**Appendix E.**  
**Plan Formulation Evolution**

## **APPENDIX E. PLAN FORMULATION EVOLUTION**

### **Changes to Selected Plan after the Draft Report**

Figure 1. Draft FR/EIS Tentatively Selected Plan.

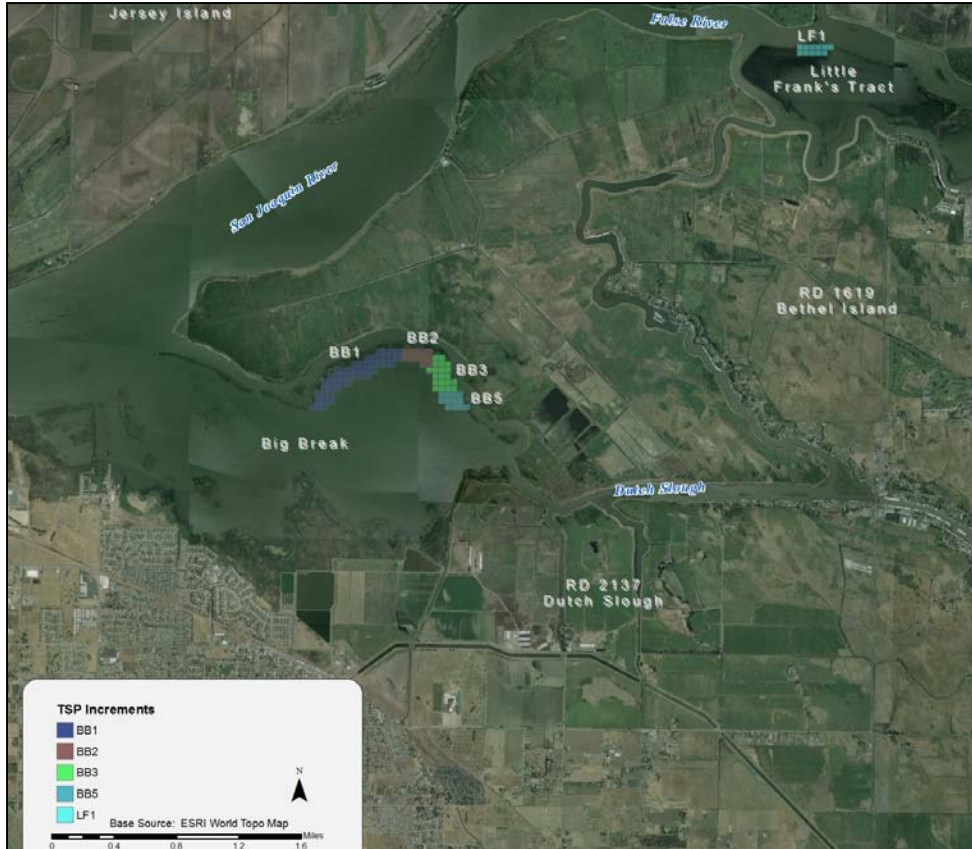
The draft FR/EIS, released for public review in April 2014, made a tentative recommendation for plan selection (Figure 1) which included the restoration of 89.5 acres of intertidal marsh at Big Break and Little Frank's Tract for an estimated cost of \$21.9 million. A primary restoration feature of the TSP was subsidence reversal in order to reestablish intertidal marsh elevations. Subsidence reversal was to be accomplished by two methods: (1) direct placement of dredged material from the Stockton Deep Water Ship Channel during annual maintenance dredging activities over a period of five years, and (2), pumping previously dredged material stockpiled at nearby locations.

Subsequent to release of the draft FR/EIS, the document underwent a number of reviews, to include policy, legal, and technical reviews. Designs, construction assumptions, and costs were revised and refined through this review process. Ultimately, costs for pumping previously dredged material increased dramatically based on refined construction assumptions. For this reason, additional options for the use of dredged material placed directly from annual maintenance dredging activities were sought. An additional "direct placement" increment was evaluated which included an additional five years of direct placement of dredged material from the Stockton Deep Water Ship Channel during annual maintenance dredging activities for an additional five years (construction years six through ten).

Based on updated costs and outputs, a revised plan (Figure 2) was identified at USACE's internal Agency Decision Milestone (ADM), which at the time included the restoration of roughly 84 acres of intertidal marsh at Big Break for an estimated cost of \$23.7 million. The revised plan does not include pumping previously dredged stockpiled material due to the high costs of moving the material; therefore restoration at Little Frank's Tract is not included, as stockpiled material was to be used for this area. Consistent with the draft FR/EIS description, subsidence reversal to reestablish intertidal marsh elevations is the primary restoration feature of the revised plan. Subsidence reversal is to be accomplished by direct placement of dredged material from the Stockton Deep Water Ship Channel during annual maintenance dredging activities over a period of ten years.

Figure 3. Recommended Plan.

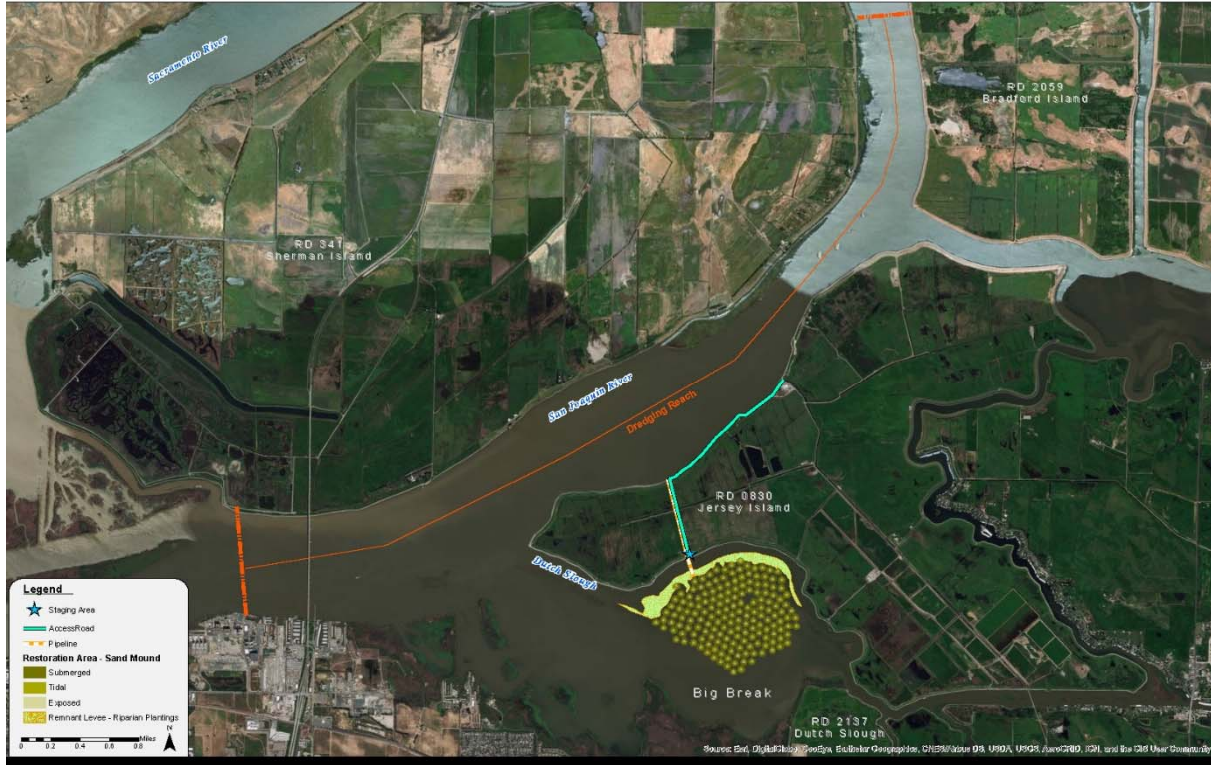
After concurrence on the revised plan during the ADM, the design of the recommended plan was developed in greater detail, consistent with USACE policy. Two factors were of particular importance throughout this process. First, additional data and information regarding the composition of dredged material to be used in the recommended plan indicate the material will be predominantly fine sand, rather than silt as previously assumed. As a sandy material will form into mounds when placed via hydraulic dredging, the design of the recommended plan changed to incorporate varying topography and channels and improve constructability. Second, building off of the change in the sediment composition, designs of the recommended plan were refined using a more diverse, multi-species, ecosystem approach, which ultimately decreased the initial overall design elevations. Both of these changes incorporated the lessons learned from the Donlon Island restoration project, which focused on a need to provide more water circulation through the site, and allowed for an improvement in aquatic habitat quality in addition to an increase in marsh wren habitat. These two factors would apply to all final alternatives under consideration in this study; therefore, previous evaluations and comparisons of alternatives were not revisited because plan selection would not change.

These refined design characteristics resulted in an increase in the size of the restoration area to 340 acres due to the varying topography, increased channels, and decrease in design elevations, with the estimated total cost decreasing to \$22.3 million; and the annual cost per acre decreasing from \$274,000 to \$66,000. Figures 3 and 4 show the revised Recommended Plan based on feasibility level design.
